**Notice of Allowability**

09/993,752

**DETAILED ACTION**  
**EXAMINER'S AMENDMENT**

FIG. 4

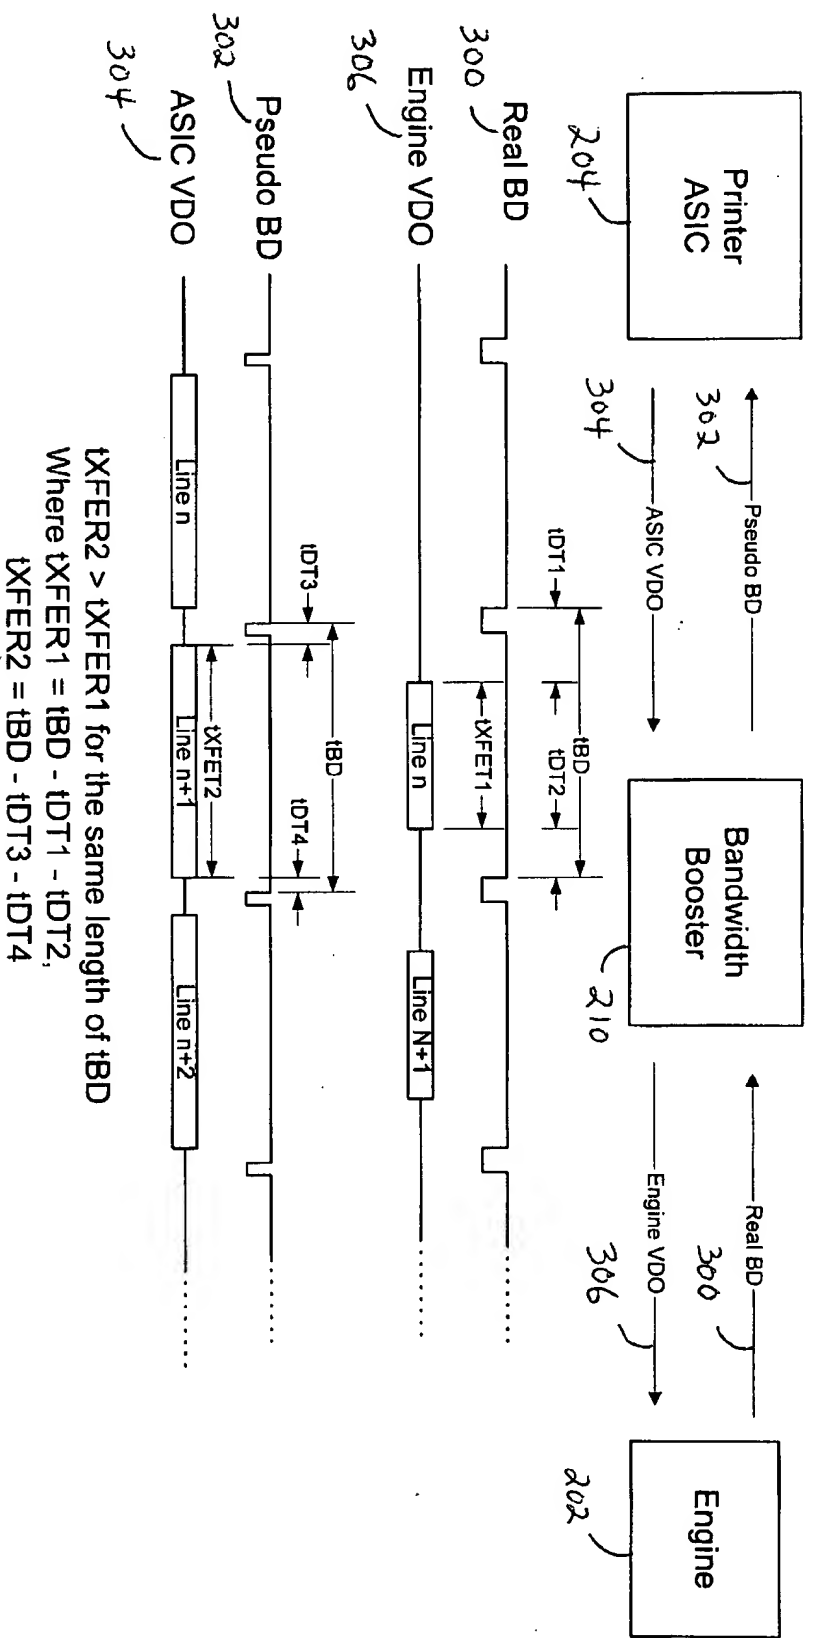
In a preferred embodiment, a bandwidth booster **210** is placed between the printer ASIC **204** and the print engine **202**. The function of the bandwidth booster **210** is to buffer the print data (shown in FIG. 4 as ASIC VDO **304**) and generate a pseudo BD **302** to the printer ASIC **204** for every real BD **300** from the print engine **202**. The time between each pseudo BD **302** will be same as the real BD **300**. Unlike a real print engine **202**, the bandwidth booster **210** can place much less dead time on the pseudo BD **302**, thus the same amount of data can be transferred over a longer period of time and, effectively, increases the bandwidth of the printer ASIC **204**. The bandwidth booster **210** then transfers the buffered data (shown in FIG. 4 as

8. Figure 4 of the disclosure has also been modified as shown in the attached drawing.
